**PLEASANT PRAIRIE PLAN COMMISSION MEETING
VILLAGE HALL AUDITORIUM
9915 39th AVENUE
PLEASANT PRAIRIE, WISCONSIN
6:00 P.M.
JULY 8, 2013**

VILLAGE STAFF REPORT OF JULY 8, 2013

TO: Jean Werbie-Harris, Community Development Director
FROM: Doug McElmury, Chief Fire & Rescue Department
CC: Lt. Thomas Clark, Fire & Rescue Department
Peggy Herrick, Assistant Planner, Community Development
SUBJECT: Review of the Tenuta Garage Project
DATE: 7/5/13

**ORDINANCE TO CREATE THE
7804 COOPER ROAD PLANNED UNIT DEVELOPMENT (PUD) PURSUANT TO
CHAPTER 420-137 OF THE VILLAGE ZONING ORDINANCE
IN THE VILLAGE OF PLEASANT PRAIRIE, KENOSHA COUNTY, WISCONSIN**

1 SITE PLAN
ALL 1:100

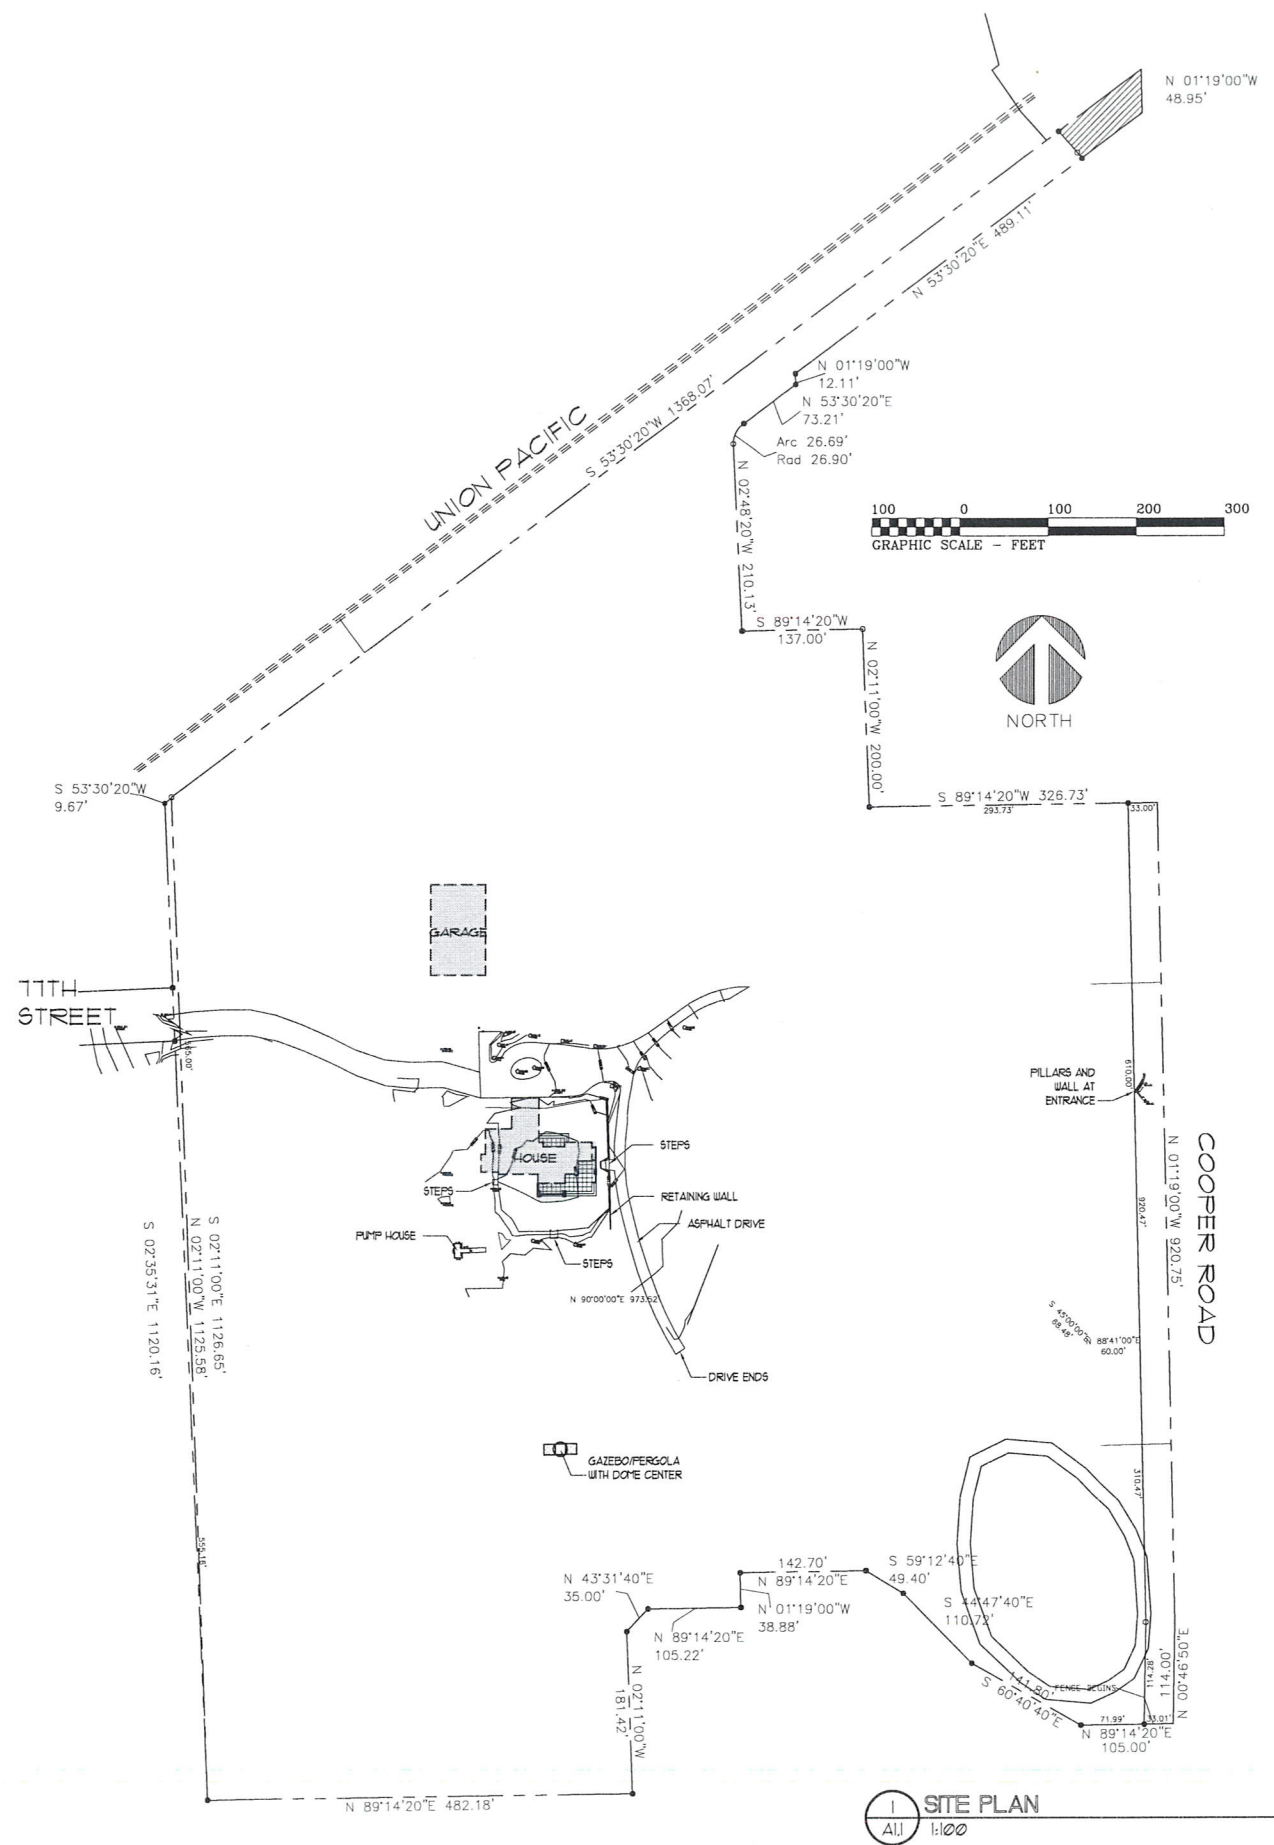
Our client would like to be permitted, in addition to his house, six accessory structures including the existing gazebo, the existing pump house structure, a 6,000 square foot garage and three future accessory structures, such as a second gazebo, a pool and a pool house.

- The site is over 30 acres, so even with a quantity of six accessory structures, the site still remains substantially undeveloped.
- Even with the home's footprint of approximately 6,200 square feet and an accessory detached garage of 6,000 square feet, if all remaining accessory structures were constructed at 1,000 square feet each, this would still result in a Floor Area Ratio of 0.0056.

- The detached garage will be setback approximately 763 feet from Cooper Road and over 298 feet from 54th Avenue. Please note that we do not front 54th Avenue. We will also be setback over 250 feet from the (perpendicular to) property line along the railroad tracks to the north.

TENUTA GARAGE
KENOSHA, WI
FLOOR PLAN, ELEVATIONS, AND SECTION DETAIL

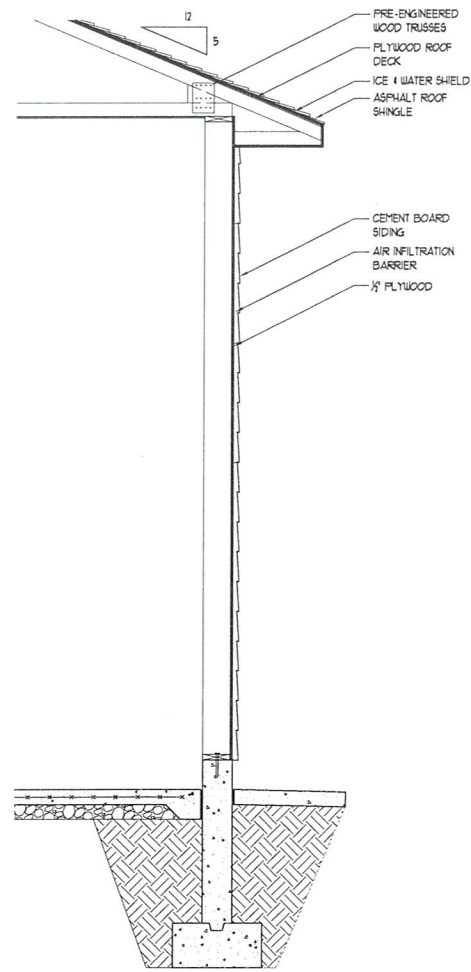
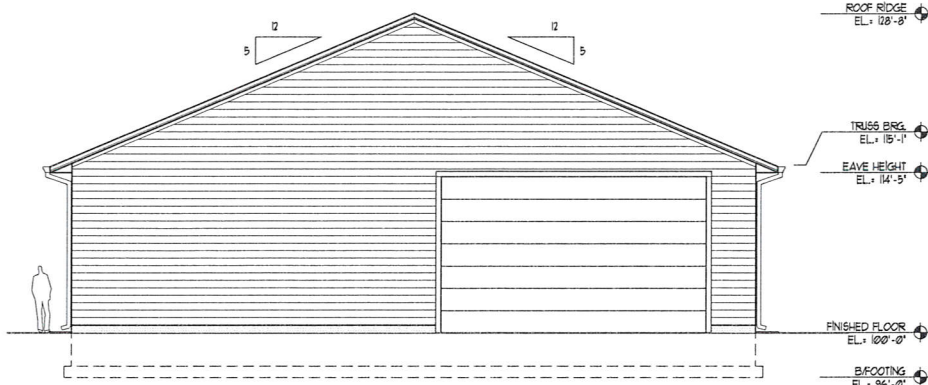
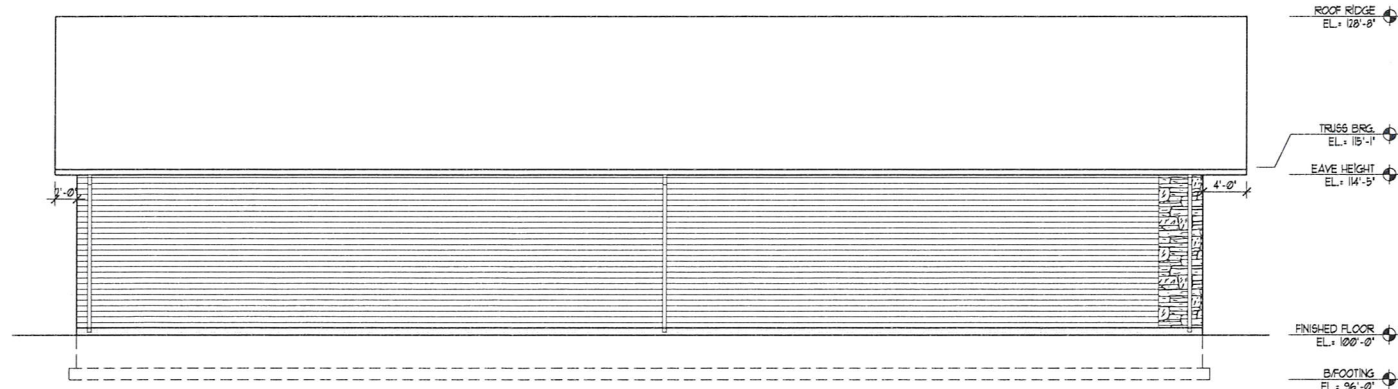
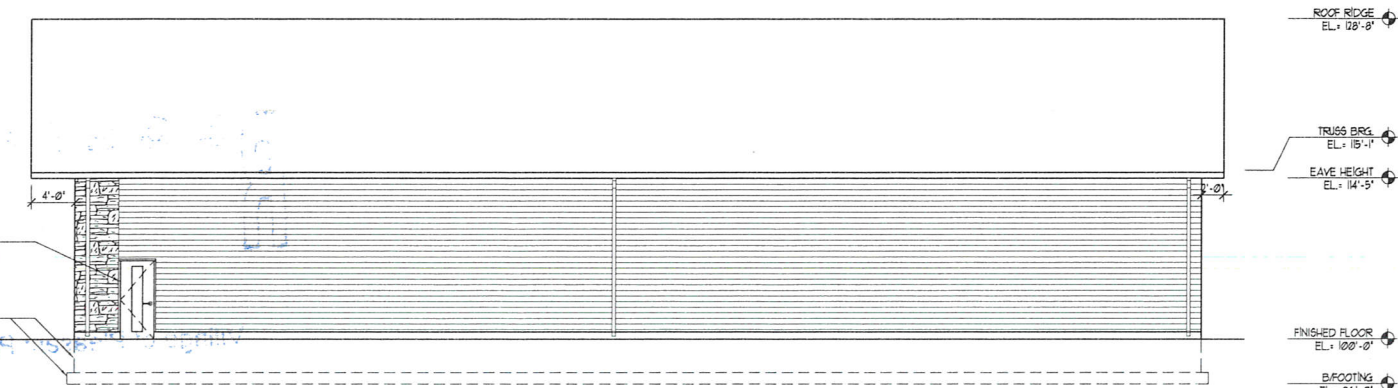
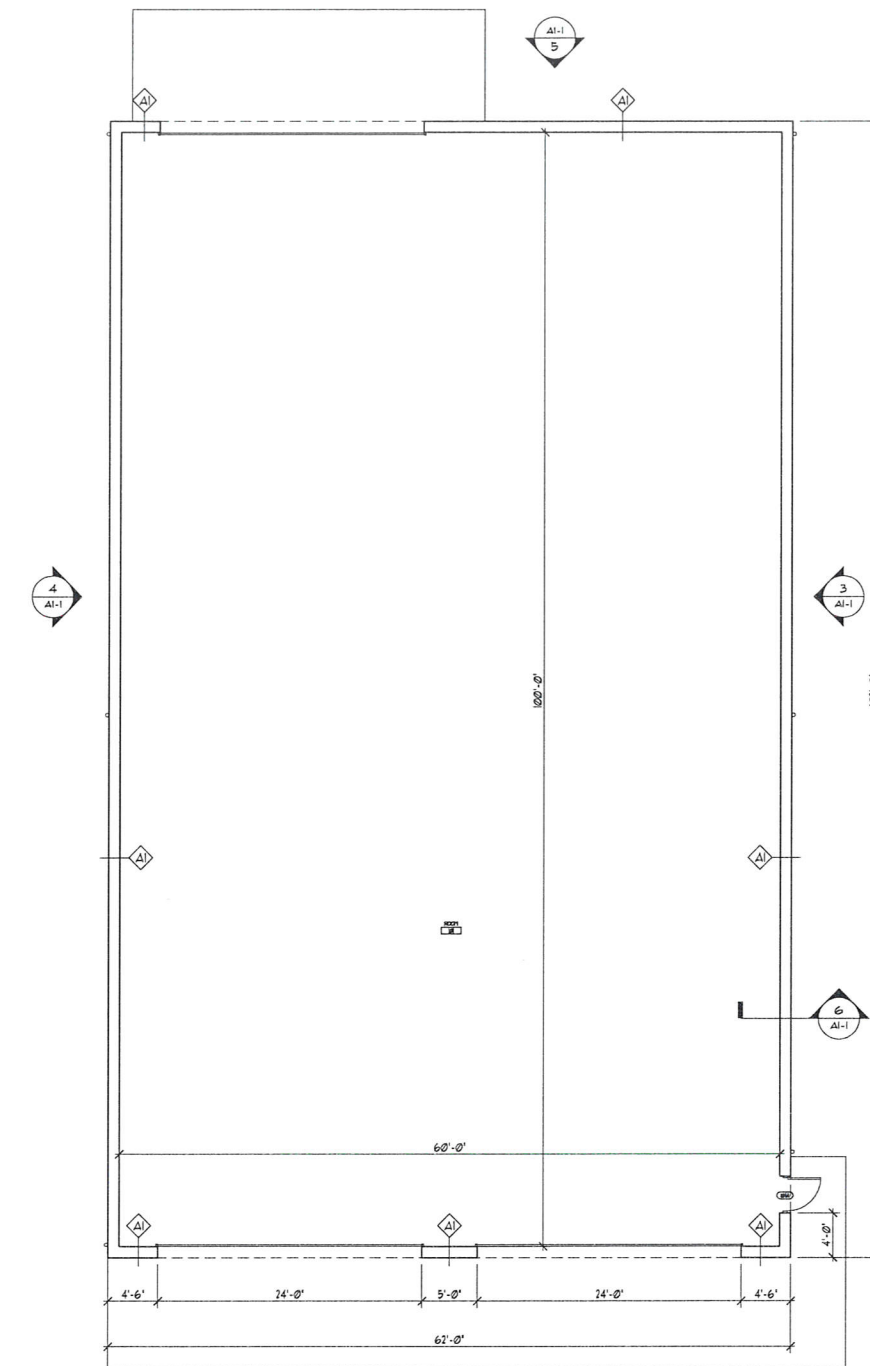
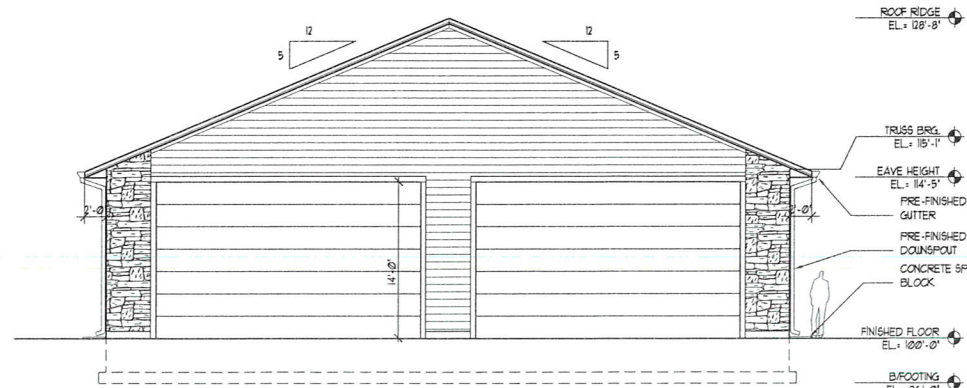
1. Provide a fire alarm. A fire alarm system would help to reduce life safety issues by providing early detection and warning to the building occupants and allow for a quick evacuation. The extremely fast rate of fire growth in large open buildings such as garages, storage buildings, pole barns, churches etc. can lead to significant structural damage early in the fire and prevent aggressive interior attacks. Combine that with the fact that there will be several high value vehicles in a large building not protected by a sprinkler system the outcome could lead to a very large dollar loss. That is not to say that all fires in this type of structure would grow in such a manner to prevent interior fire attack, but is a realistic possibility.

2. Provide a sprinkler system. A fire sprinkler system is needed due to the hazards involved with a repair garage and certain types of storage.
3. Compartmentalize the building. Compartmentalization with fire resistive construction would also help to slow the spread of fire.

- (iv) Any accessory building larger than 3,500 square feet within the DEVELOPMENT, shall:
 - (a) Provide a fire alarm. A fire alarm system would help to reduce life safety issues by providing early detection and warning to the building occupants and allow for a quick evacuation. The extremely fast rate of fire growth in large open buildings such as garages, storage buildings, pole barns, churches etc. can lead to significant structural damage early in the fire and prevent aggressive interior attacks..

- (b) Provide a sprinkler system. A fire sprinkler system is needed due to the hazards involved with a repair garage and certain types of storage.
 - (c) Compartmentalize the building. Compartmentalization with fire resistive construction would also help to slow the spread of fire.
